25 October 2019

16009

SSD 7484 – MODIFICATION 4 RESPONSE TO SUBMISSIONS AND REQUEST FOR FURTHER INFORMATION 23-33 & 35-39 BRIDGE STREET, SYDNEY – THE SANDSTONE PRECINCT

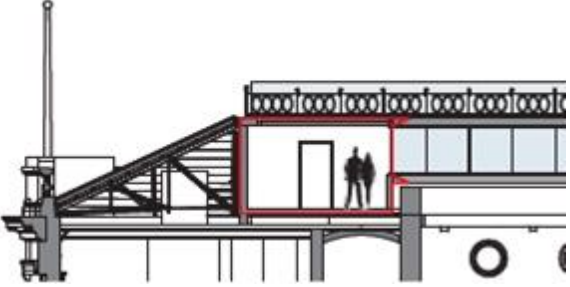
Strong Room	
The Design Report indicates that the Strong Room will be returned to its original volume by removing floors and partitions added in the 1950's and be used as a reception, lounge, bar and function arrival space. I note a detailed strategy for demolition and conservation will be developed further, but it's unclear how and when this strategy will be secured and delivered.	The proposed demolition of intrusive infill slabs in order to reinstate the original volume was submitted as part of the Mod 4 drawing package. The schedule of conservation works outlines the strategy for how this will be secured and delivered, as required under condition B44.
Landscaping
